QUEENSLAND FLOODS COMMISSION OF INQUIRY

**Technical Review of Flood Frequency
Analysis Report by WMA Water (18
September 2011), specifically as it
relates to Ipswich City Council**

Ipswich City Council

R. B18414.003.00.doc
October 2011

Figure 5-1 Bremer River Timeline

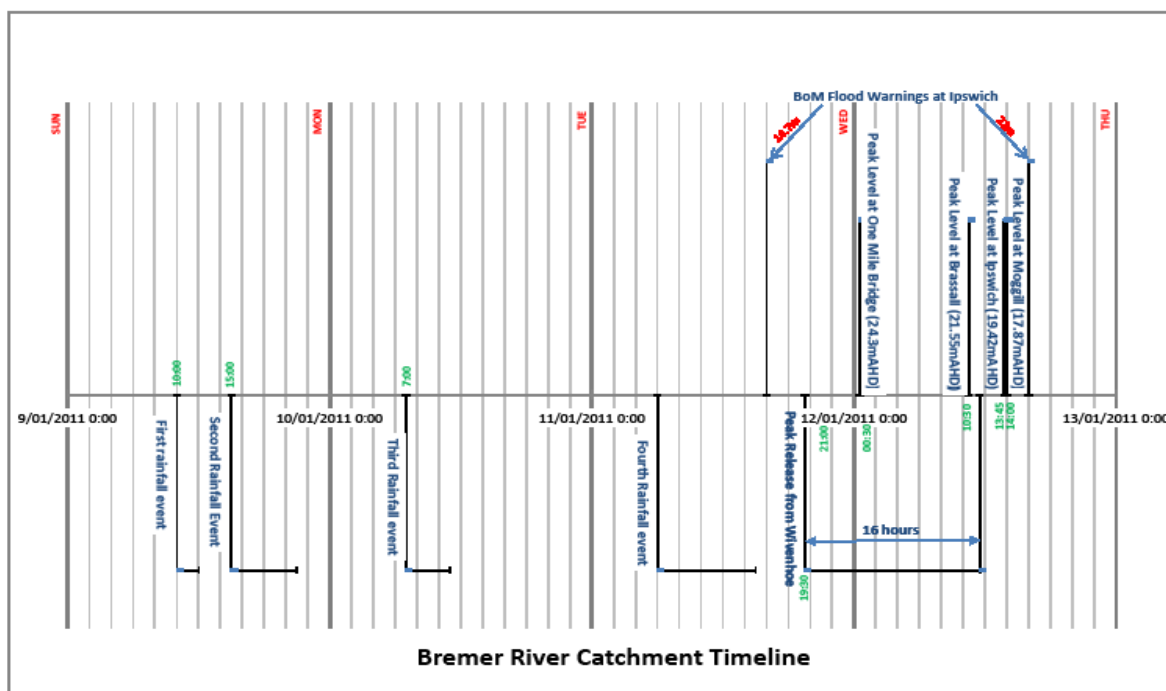
With regards to the comment in paragraph 65 of WMA Water's report that the Bremer River and Brisbane River peak occur at the same time, it is not reported how flows on the Bremer River were derived. The modelling carried out as part of this report (see Chapter 6) indicates that the peak water

level from the Bremer only flow occurred at around 0440hours on 12 January 2011, whereas the peak in the Brisbane River occurred at the Moggill gauge at approximately 1400hours on 12 January. Figure 5-1 illustrates the timeline summarising rainfall, peak flood release from Wivenhoe Dam and associated warning information.

Peak flooding in Ipswich was significantly influenced by back-up flooding from the Brisbane River. Peak flooding in the Brisbane River at the confluence of the Bremer River was a result of runoff from the upper Brisbane River catchment system including major discharge from Wivenhoe Dam (which peaked at 1930 hours on 11 January 2011), combined with significant runoff from the Lockyer Creek catchment, with the peaks of dam discharge and Lockyer Creek coinciding. Hence, flooding in Ipswich was at least in part influenced by the timing of releases of water from Wivenhoe Dam but was exacerbated by the major flood event in Lockyer Creek, which was coincident with dam release flows.

Figure 6-1 SKM Modelled Water Levels and Flows

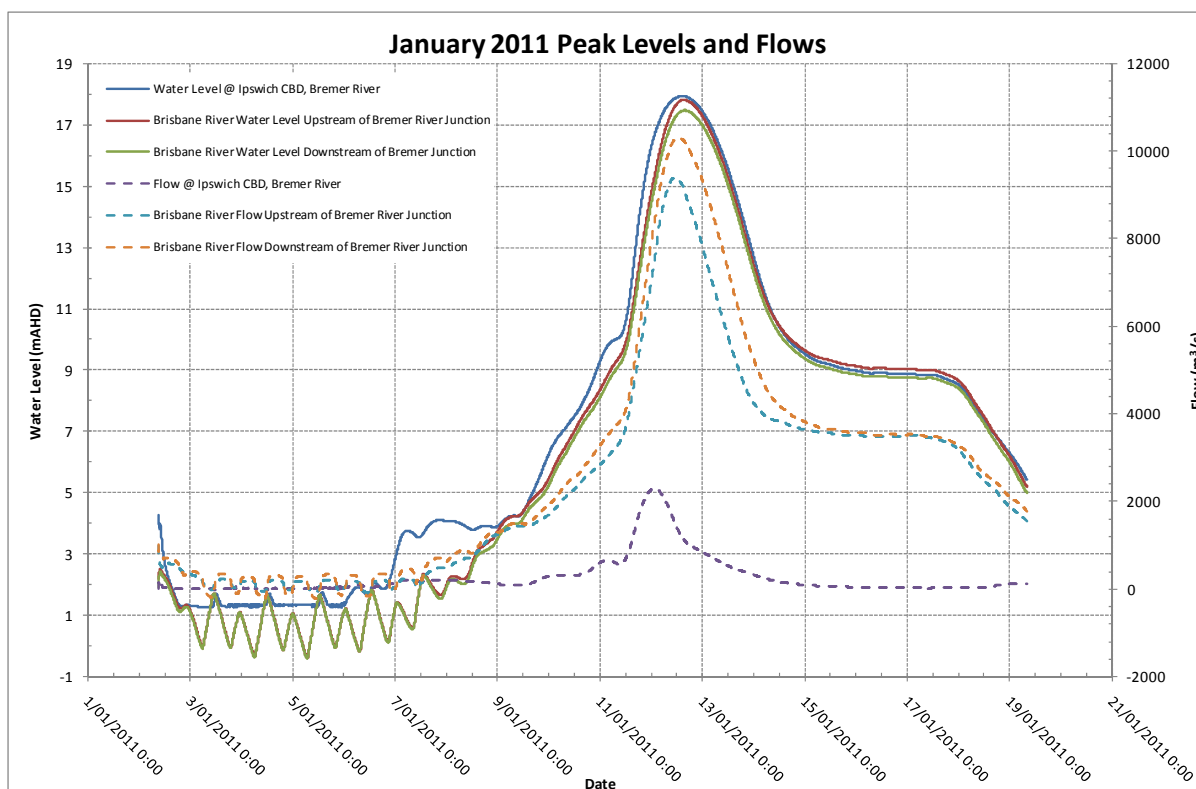
The MIKE11 model estimates the peak water level at Ipswich to be 17.931mAHD. The recorded peak water level was 19.42mAHD as illustrated in Figure 6-1 below.

URBS slightly overestimates the peak flow by approximately $150\text{m}^3/\text{s}$ (which is around 1% of the total flow). The MIKE11 modelled peak flow of $2,300\text{m}^3/\text{s}$ equates to a design flow of between 20 and 50 year Average Recurrence Interval (ARI) (Sargent, 2006). The actual measured peak flow at Ipswich was $2,277\text{m}^3/\text{s}$.

Figure 6-2 Option A4 Water Levels and Flow

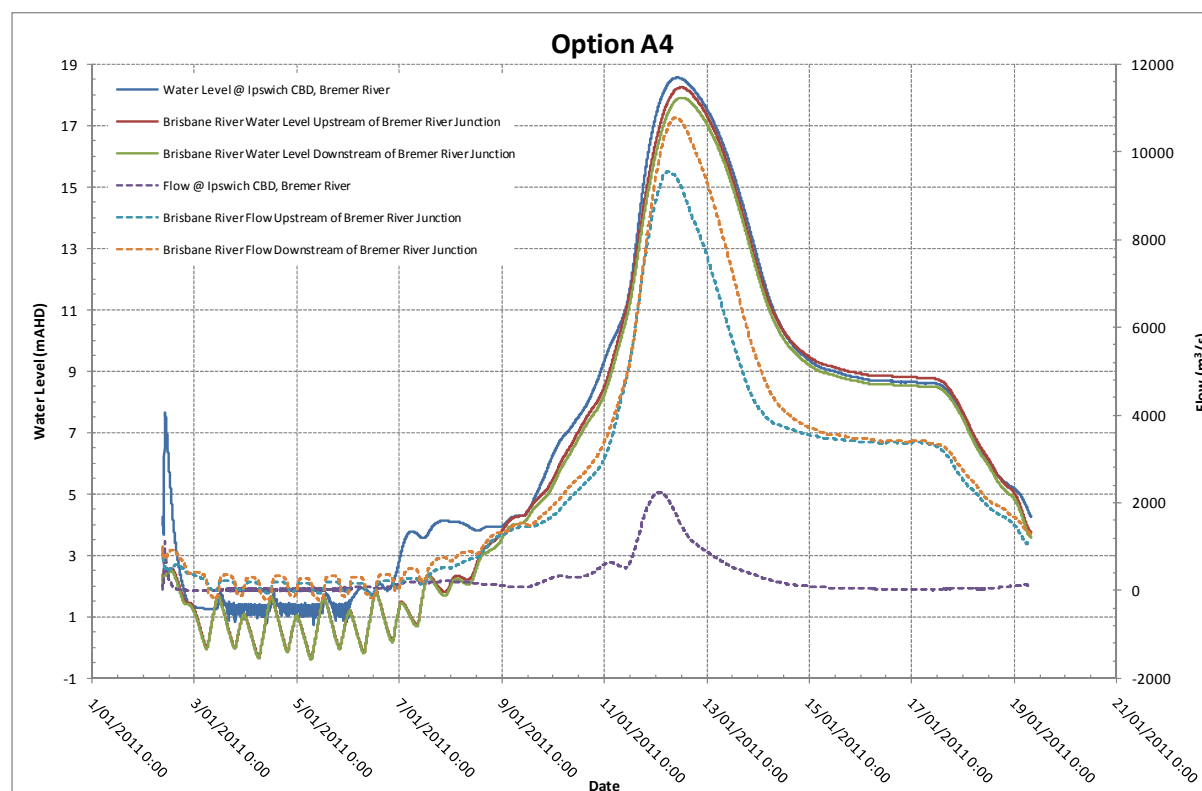
Our analysis indicates the following for Ipswich Option A4 scenario as shown in Figure 6-2.

- Peak water level at Ipswich CBD increases over that predicted for the actual flood event (Figure 6-1) by 0.64m; and
- Peak flow at Ipswich CBD is 2,238m³/s.

i.e. Option A4, if technically possible, could have worsened flooding in Ipswich by 0.64m.

Figure 6-3 Option A5 Water Levels and Flow

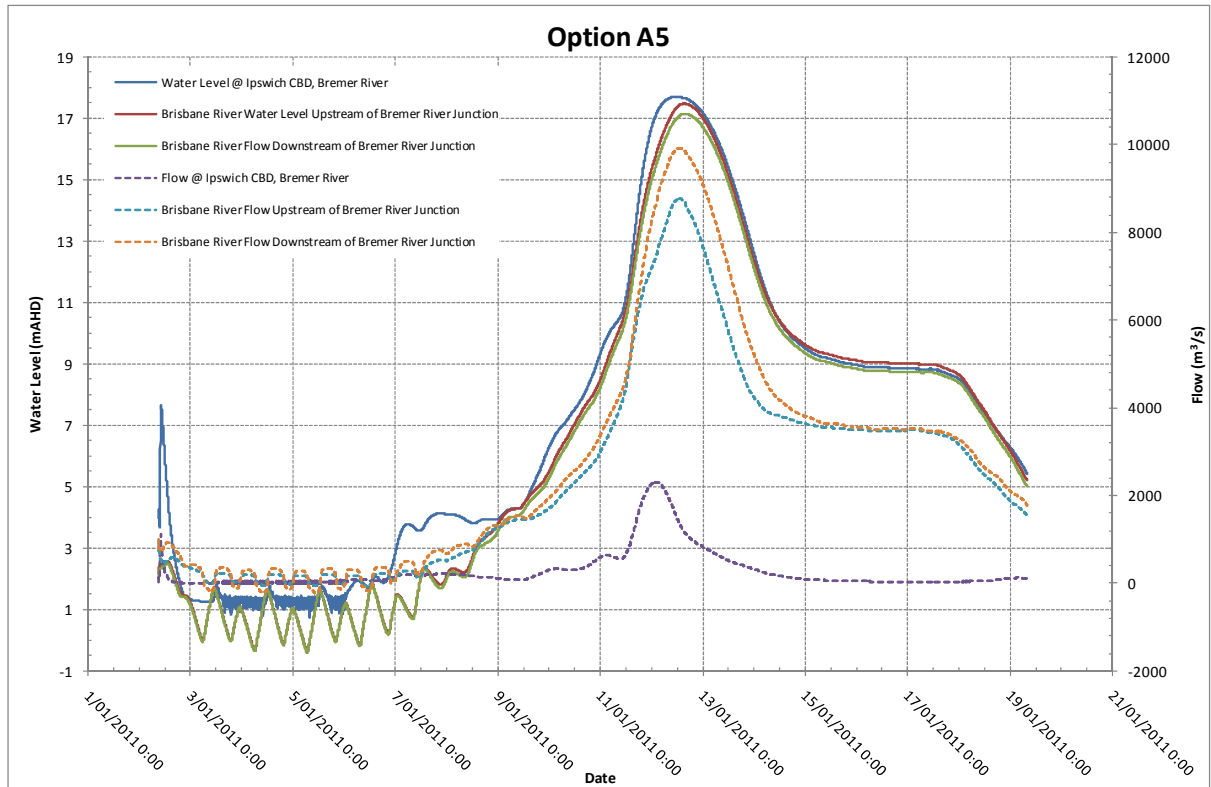
Our analysis indicates the following for Ipswich Option A5 scenario as shown in Figure 6-3.

- Peak water level at Ipswich CBD decreases by 0.83m; and
- Peak flow at Ipswich CBD is 2,310m³/s.

i.e. Option A5, if technically possible, could have reduced flooding in Ipswich by 0.83m.

Figure 6-4 Option B Water Levels and Flow

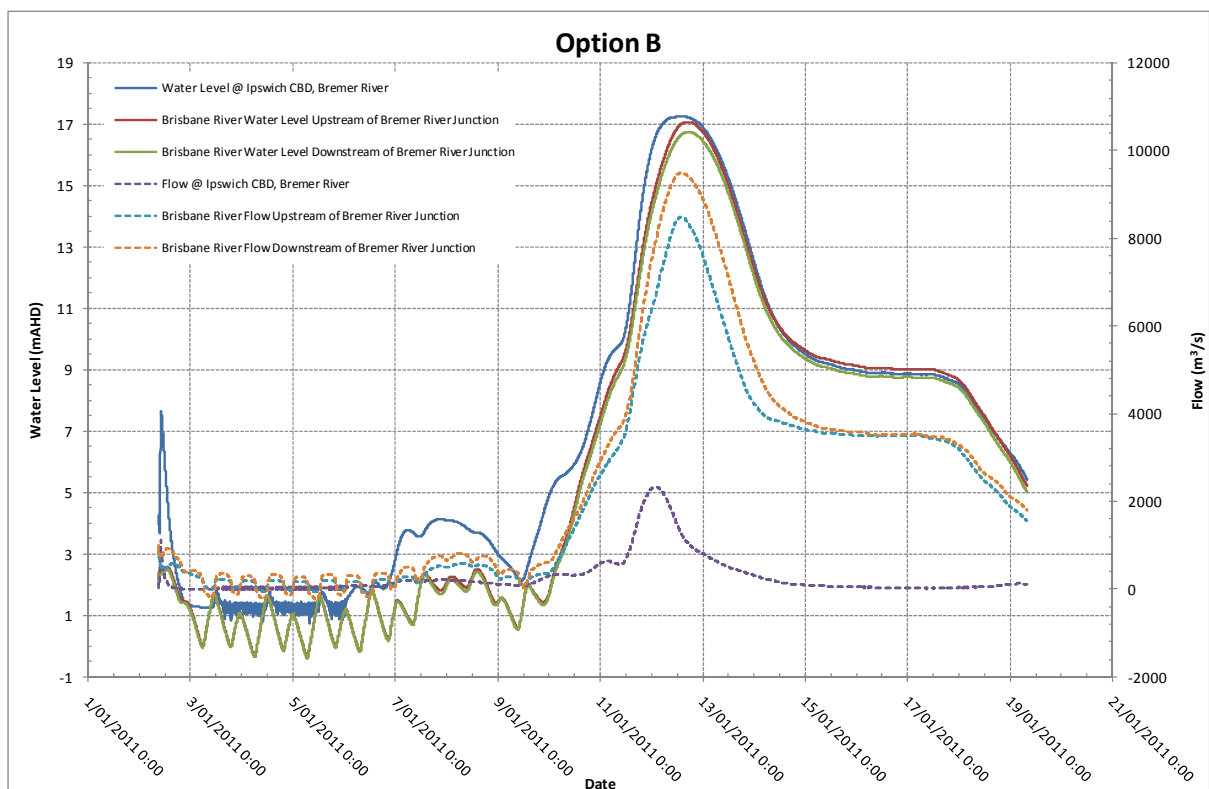
Our analysis indicates the following as shown in Figure 6-4.

- Peak water level at Ipswich CBD is decreased by 0.68m; and
- Peak flow at Ipswich CBD is 2,330m³/s.

i.e. Option B could have reduced flooding in Ipswich by 0.68m.

Figure 6-5 Option C Water Levels and Flow

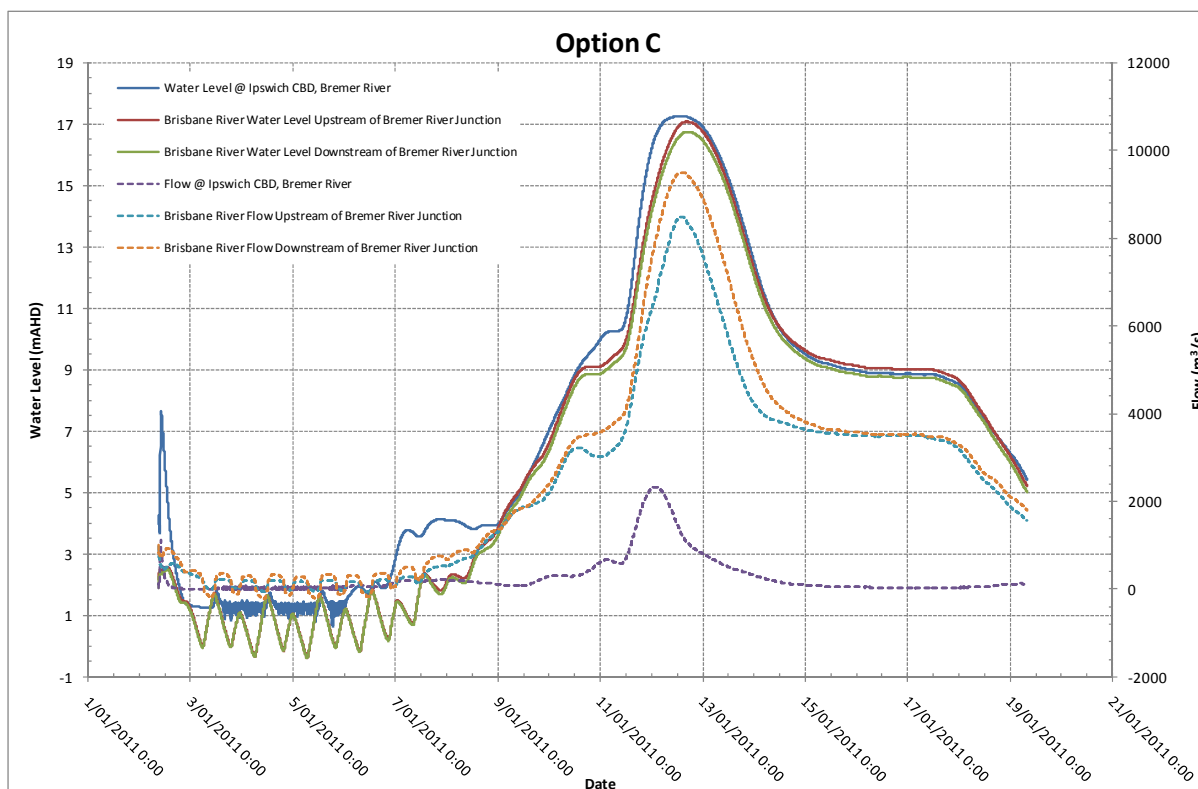
Our analysis indicates the following as shown in Figure 6-5.

- Peak water level at Ipswich CBD decreased by 0.67m; and
- Peak flow at Ipswich CBD is 2,331m³/s.

i.e. Option C, if technically possible, could have reduced flooding in Ipswich by 0.67m.

Figure 6-6 Option D Water Levels and Flow

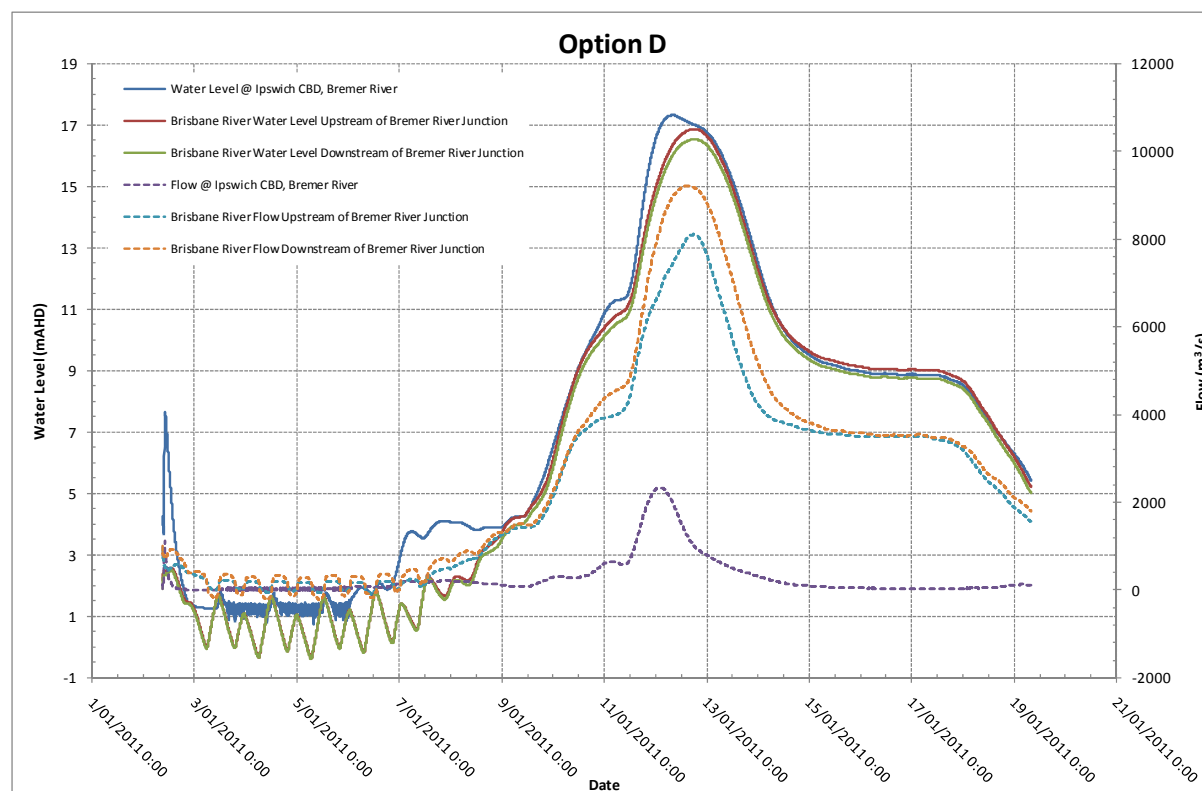
Our analysis indicates the following as shown in Figure 6-6.

- Peak water level at Ipswich CBD decreases by 0.6m; and
- Peak flow at Ipswich CBD is 2,334m³/s.

i.e. Option D, if technically feasible, could have reduced flooding in Ipswich by 0.6m, noting WMA Water's comments that, in reality, this option is not plausible.

Figure 6-7 Delayed Release Scenarios

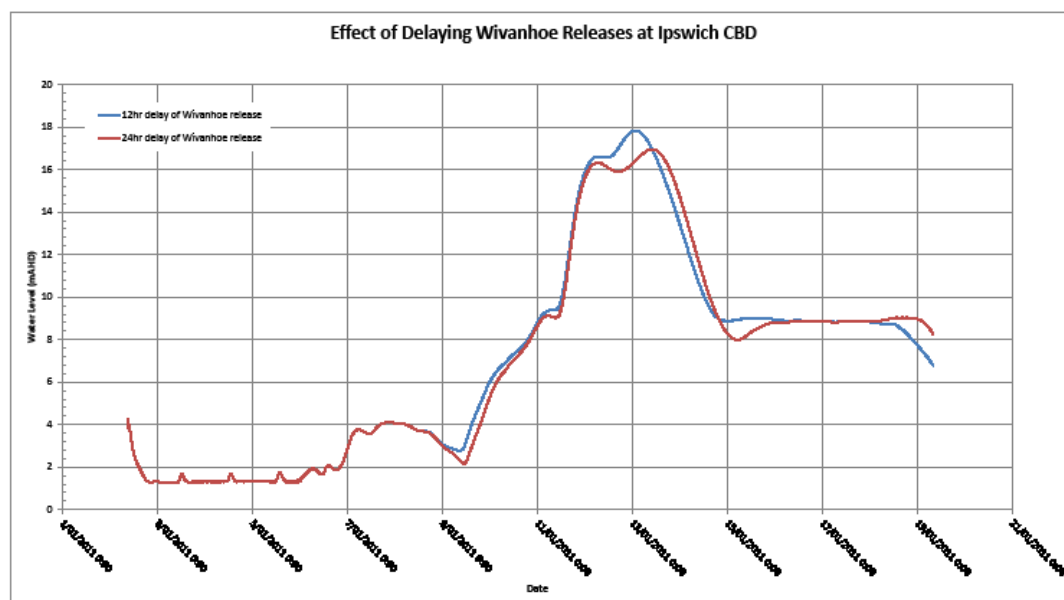
Our analysis indicates the following as shown in Figure 6-7.

The longer the delay in dam release, the greater the reduction in flood levels in Ipswich.

A delay of 24 hours in Strategy W4 release would have reduced flooding in Ipswich by about a metre. This would not be possible without major dam flood storage compartment increases and dam raising.

Figure 7-1 Flood Level Classification (BoM, 2011)

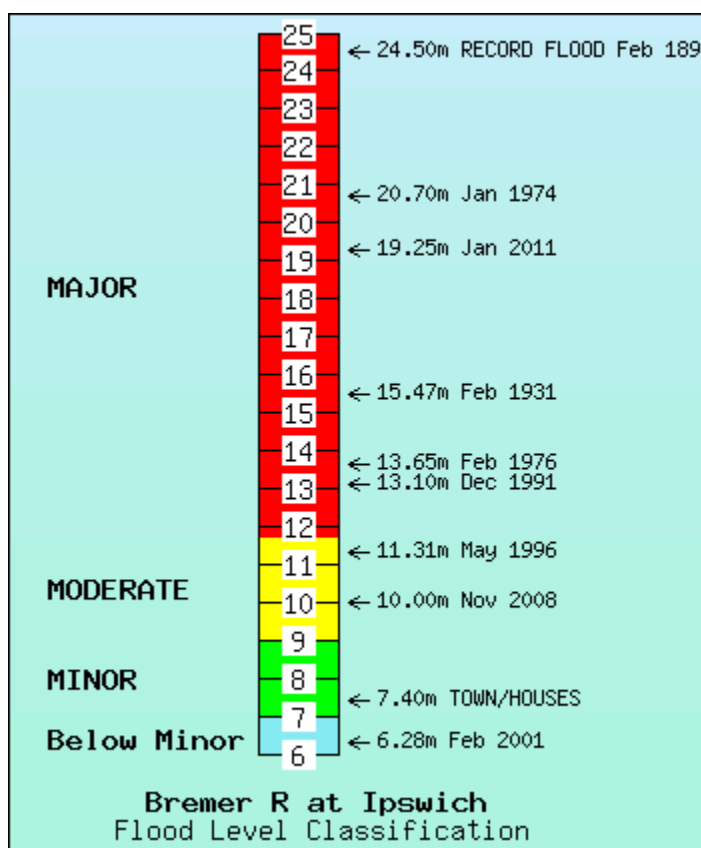
Our analysis has clearly illustrated the effect of the Brisbane River flows at the Ipswich CBD. By isolating the effects of the Bremer River only flow, we have demonstrated that the peak Bremer River flow was between the ARI 20 year and 50 year ARI event based on design flood flow estimates by Sargent (2006). When the corresponding water level of 14.09m AHD derived for this design flow (in the absence of significant Brisbane River flooding) is compared to the Ipswich flood level classification from the BoM, it can be seen that this event is within the lower end of the major category.

When the effects of the flood in the Brisbane River, the releases from the Wivenhoe Dam and the flow from Lockyer Creek are taken into account, the measured peak was 19.25m AHD.
